ADDENDUM NO. 01

Clark-Pleasant WCHS Phase 4
300 E Main St.
Whiteland, IN 46184

This Addendum consists of Pages ADD 1-1 through ADD 1 - 2 and attached Lancer Associates of Architects, Addendum No. 01, October 23, 2025, consisting of 6 pages and 38 drawings.

SECOND FLOOR TECHNOLOGY PLAN -
UNIT D
1/8" = 1'-0"

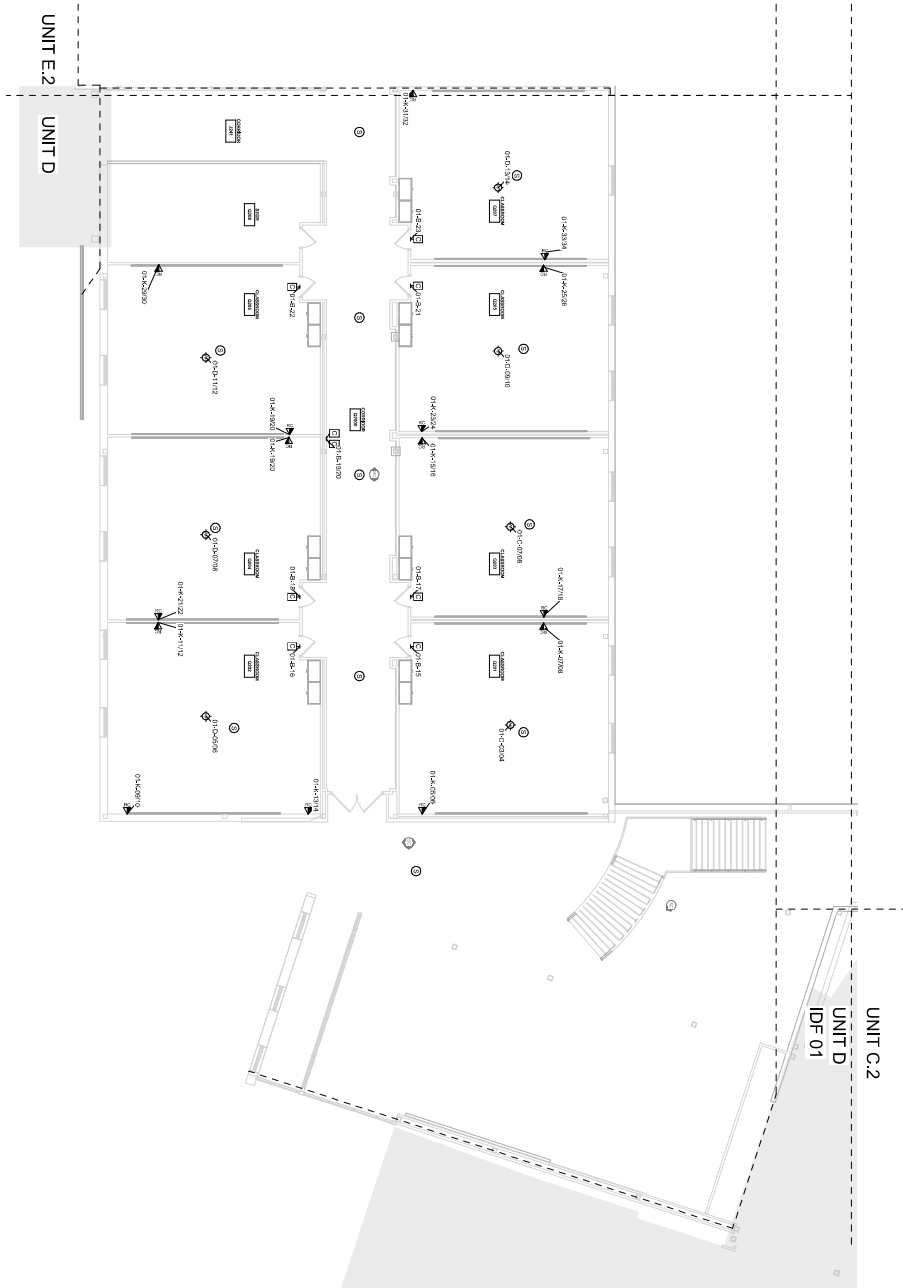
- 11) SHEET T202D – SECOND FLOOR TECHNOLOGY PLAN – UNIT D
 - a) Shifted data tags to improve device visibility on sheet.
- 12) SHEET T202E.1 – SECOND FLOOR TECHNOLOGY PLAN – UNIT E.1

EXISTING TELECOM RACK ELEVATIONS

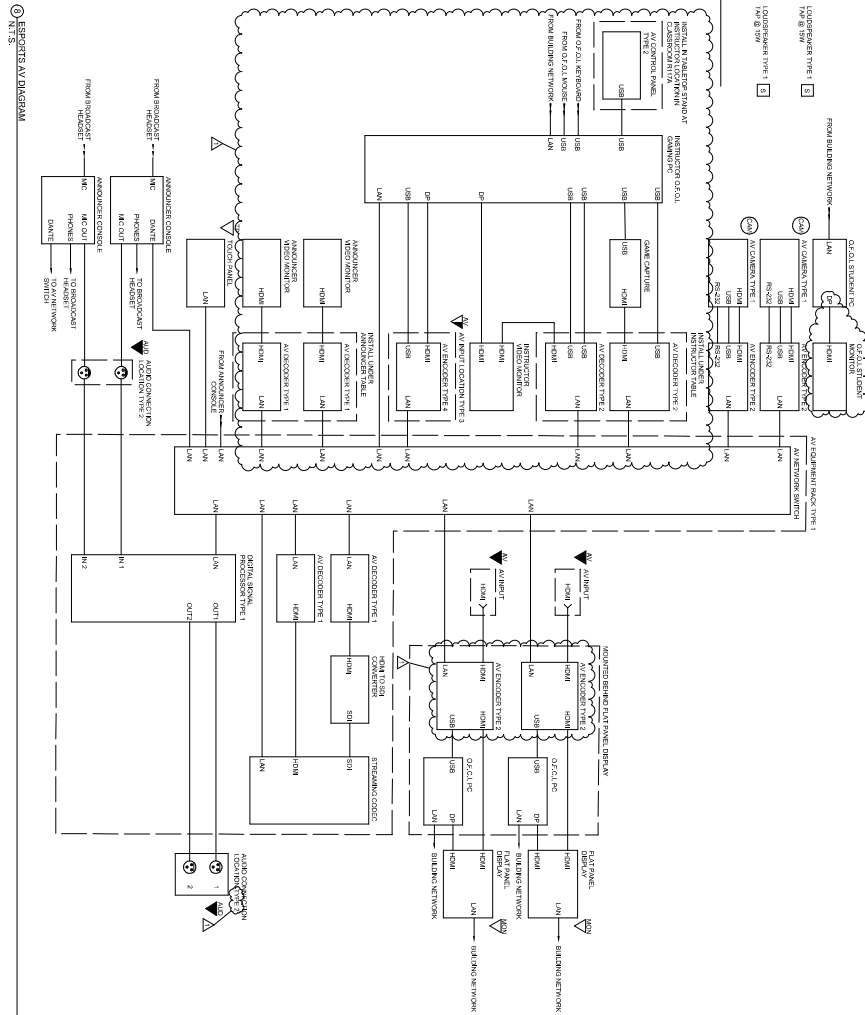
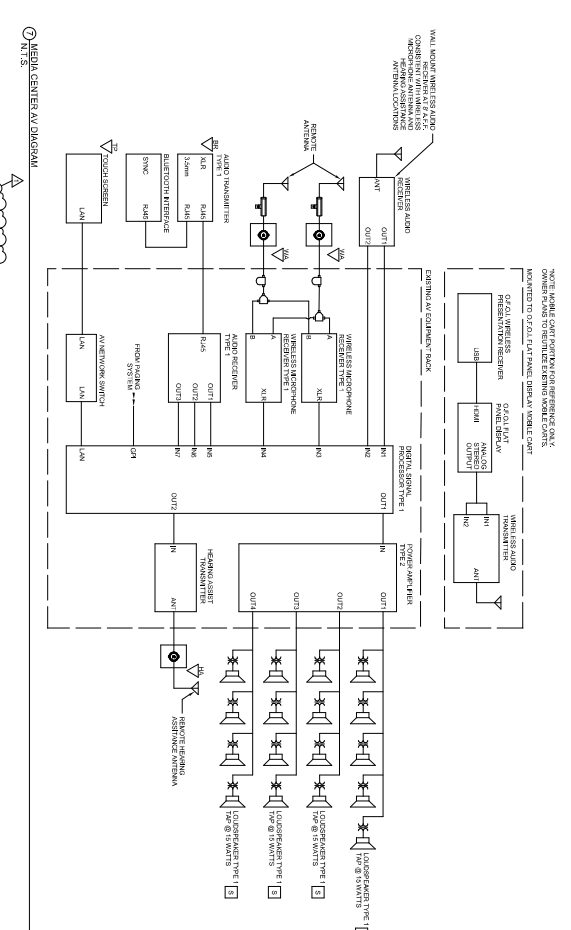
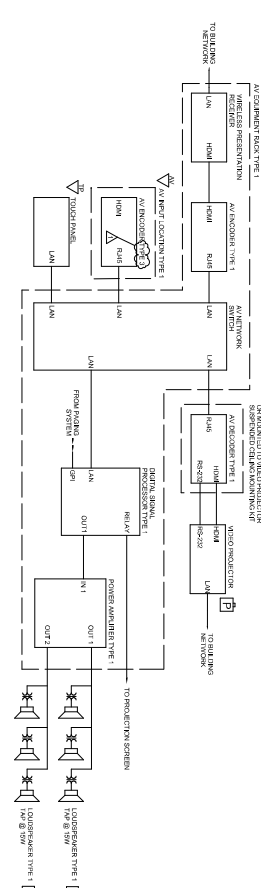
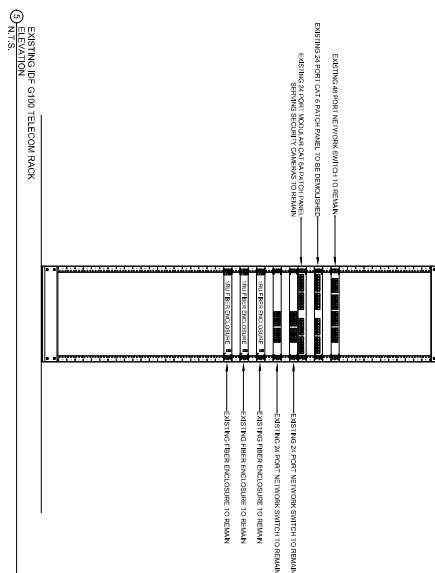
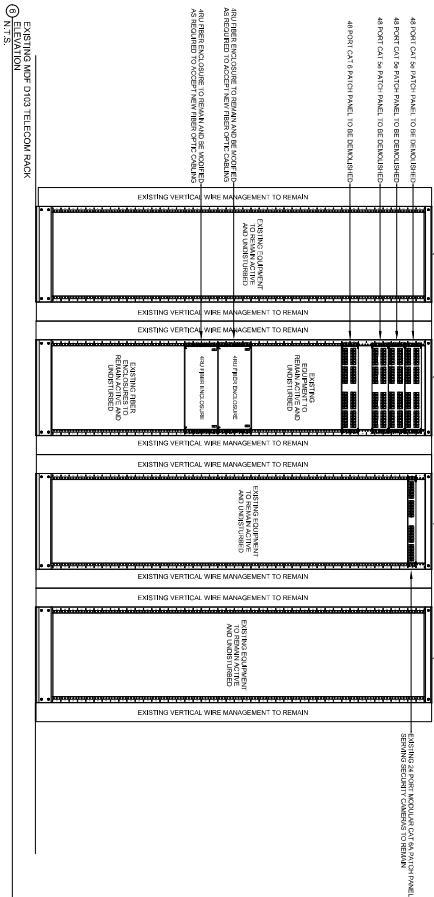
- 16) SHEET T301 – EXISTING TELECOM RACK ELEVATIONS
 - a) Updated existing IDF Candy telecom rack elevation to reflect current layout.
- 17) SHEET T302 – NEW TELECOM RACK ELEVATIONS
